Appendix IS-3

Geotechnical Feasibility Report

SOILS REPORT APPROVAL LETTER

TRACT: 1988 // LANDER TRACT NO. 2 (M P 4-57)
LOT(S): 6-8 // 1-4 & 8
LOCATION: 6450 - 6562 W SUNSET BLVD // 1420-1454 N. Wilcox Ave. and 1445-1447 & 1413-1443 N Cole Pl.

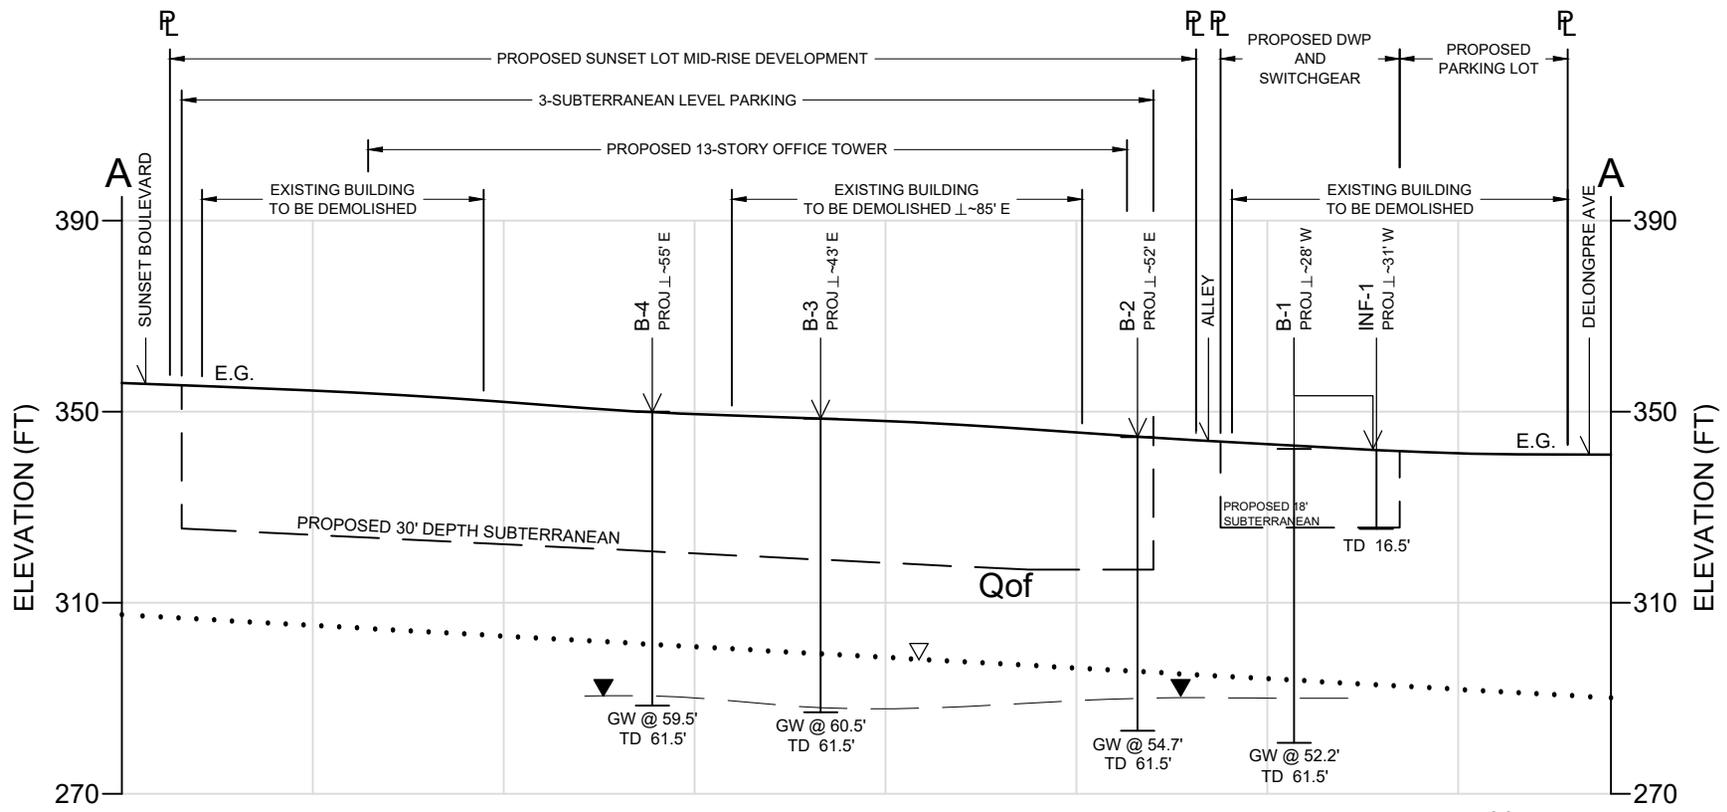
In the report Figures, Figure 4 – Cross Section A-A’ should be amended such that the cross section is labelled with A’ at the southern extent of the section.
